CITY OF WICHITA

Wichita-Sedgwick County Metropolitan Area Planning Department

Re: **BZA2026-00068:** Administrative Adjustment in the City to reduce the east street side setback from 15 feet to 12 feet to construct a duplex on property zoned TF-3 Two-Family Residential District, generally located one-quarter mile east of South Clifton Avenue and one-quarter mile north of West 63rd Street South.

Legal Description: Lot 14, Block G, Swaney Farm Addition, Wichita, Sedgwick County, Kansas.

SITE PLAN

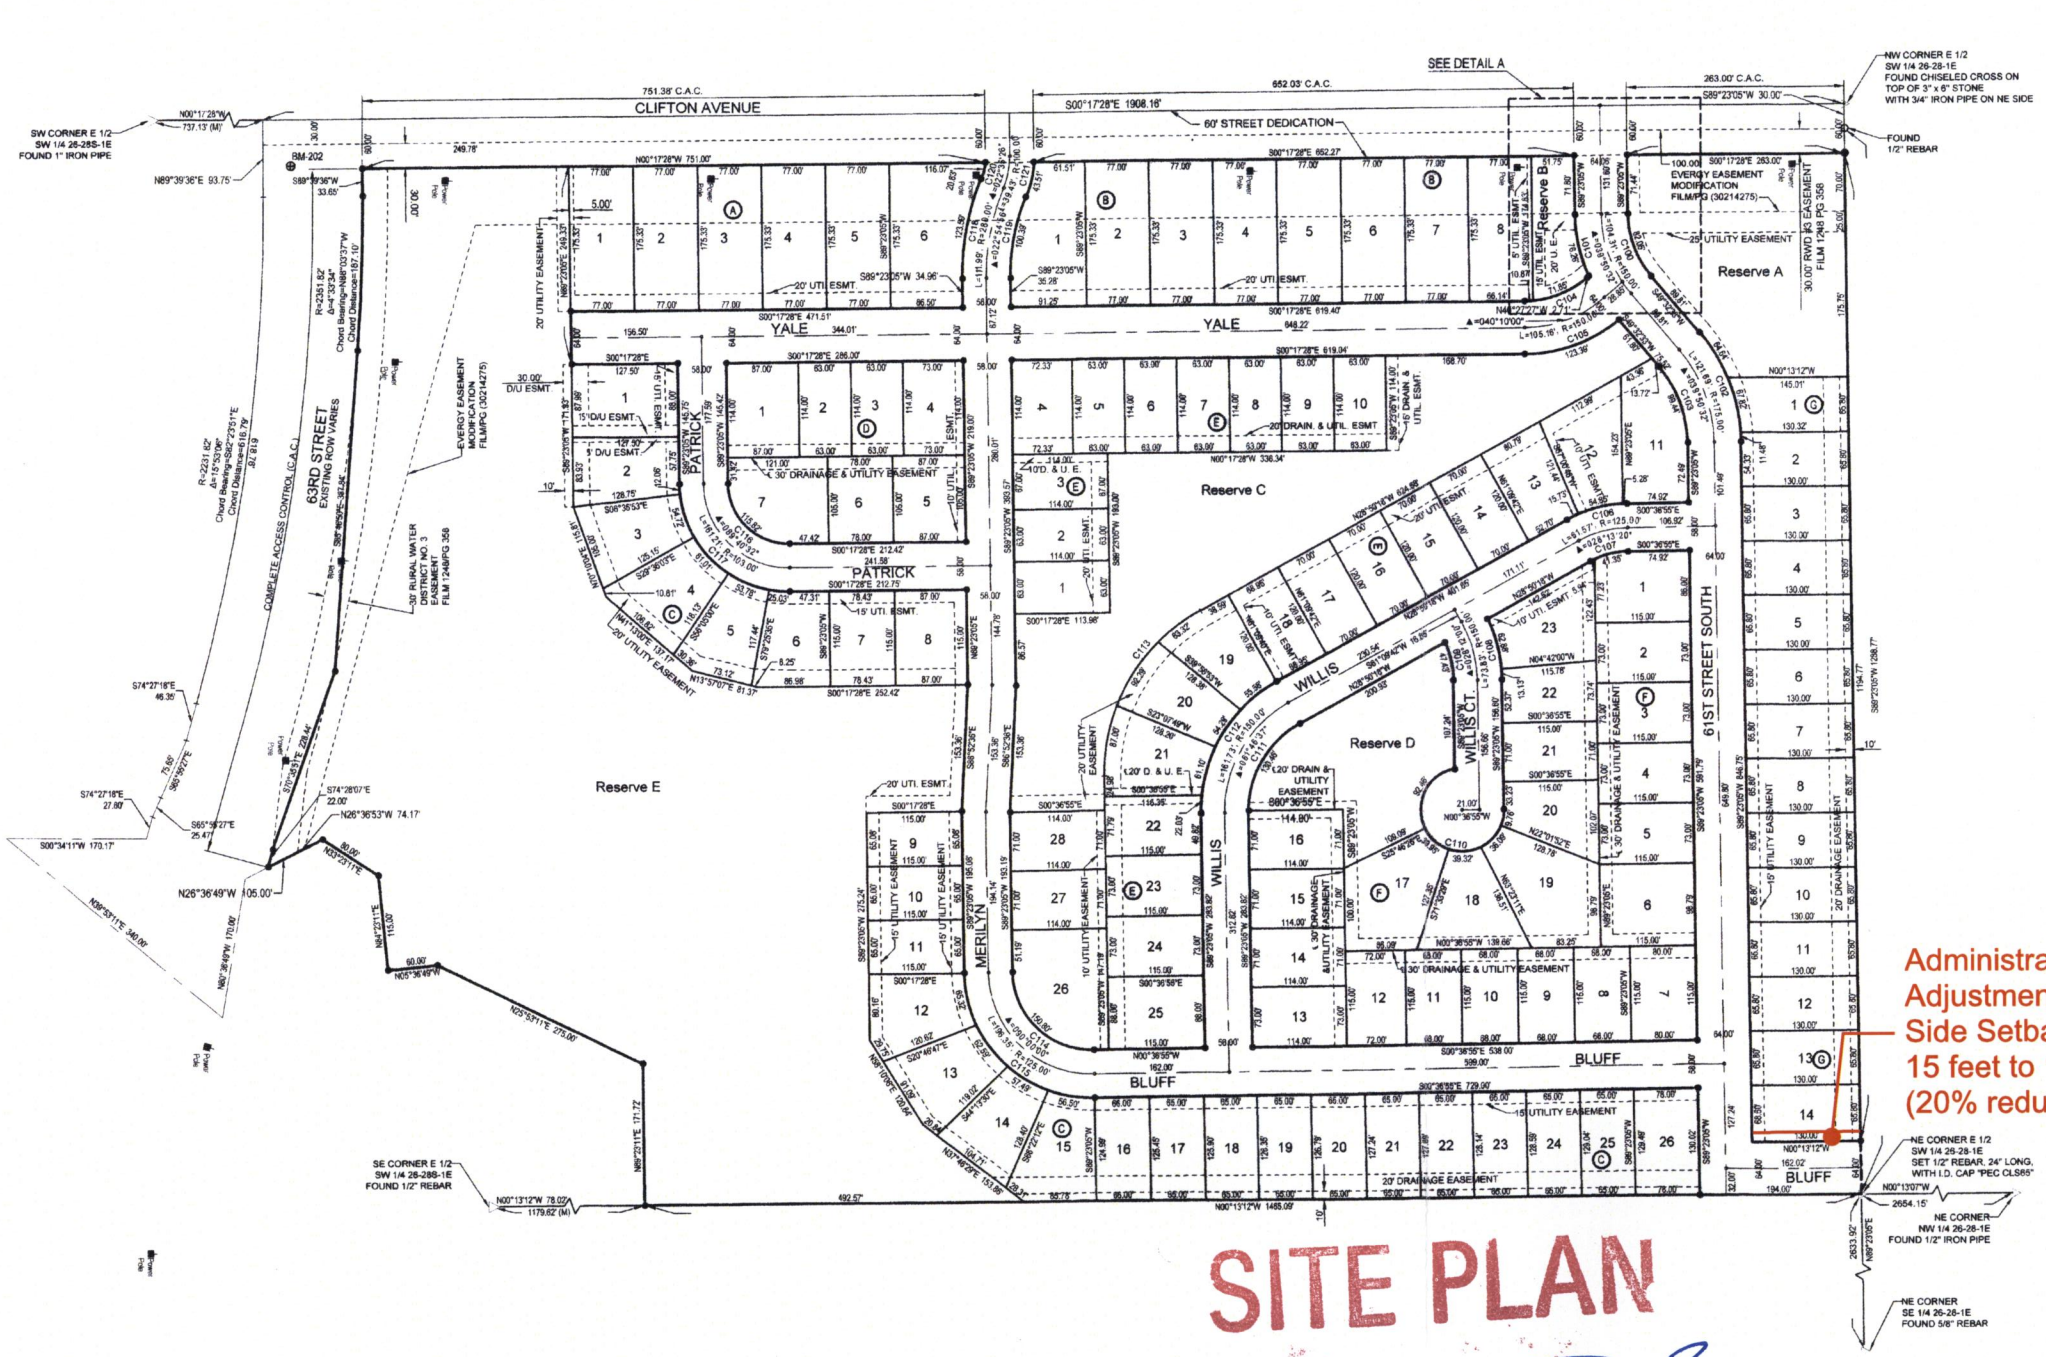
We have reviewed your request for a Zoning Adjustment to reduce the east street side setback from 15 feet to 12 (20 percent) on the aforementioned property to construct a duplex. The street side setback in question is not platted.

3) The setback reduction shall apply only to the 12-foot east street side setback as illustrated on the approved site plan. All other structures or additions on the subject property shall conform to the setbacks permitted by the Unified Zoning Code unless a separate Zoning Adjustment or Variance is granted.

Administratively Adjustment Street Side Setback from 15 feet to 12 feet (20% reduction)

Our signatures below indicate that the Zoning Adjustment to reduce the east street side setback from 15 feet to 12 feet is hereby GRANTED, subject to the following conditions:

APPROVED 7/14/24 BY BZA 24-68
